January 24, 2002

Edwin I. Hatch Nuclear Plant  
Response to Request for Additional Information  
Relative to  
Request to Revise Technical Specifications:  
Quarterly Surveillance Extension

Edwin I. Hatch Nuclear Plant  
Response to Request for Additional Information  
Technical Specifications Quarterly Surveillance Extension Request

**FIGURE E-1**  
**TYPICAL TRM INSTRUMENTATION CROSS-REFERENCE TABLE**

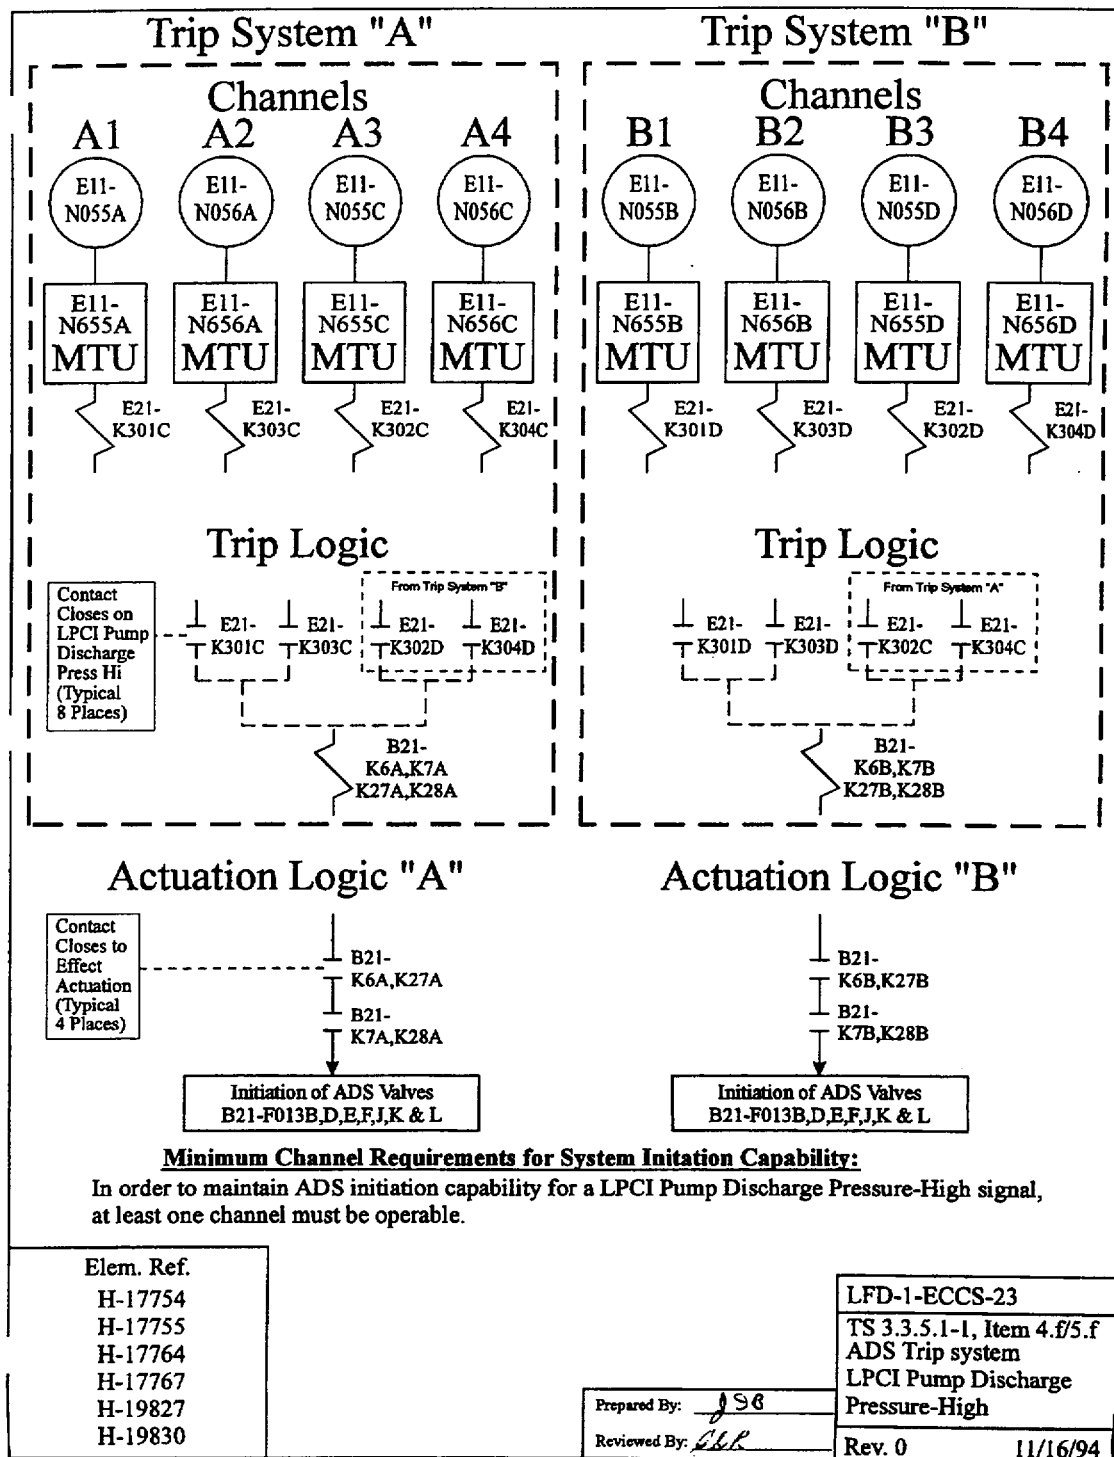
**Provide list of equipment and test boundaries included in a channel functional test .**

Since the NRR reviewers are not on distribution for the TRMs, the following response is provided for information only in support of the NRR's request. A page from TRM Table T10.1-1, which lists instrumentation associated with various Specifications, and LFD-1-ECCS-23, which shows the defined boundaries for a specific instrumentation loop, are provided as Figures E-1 and E-2, respectively.
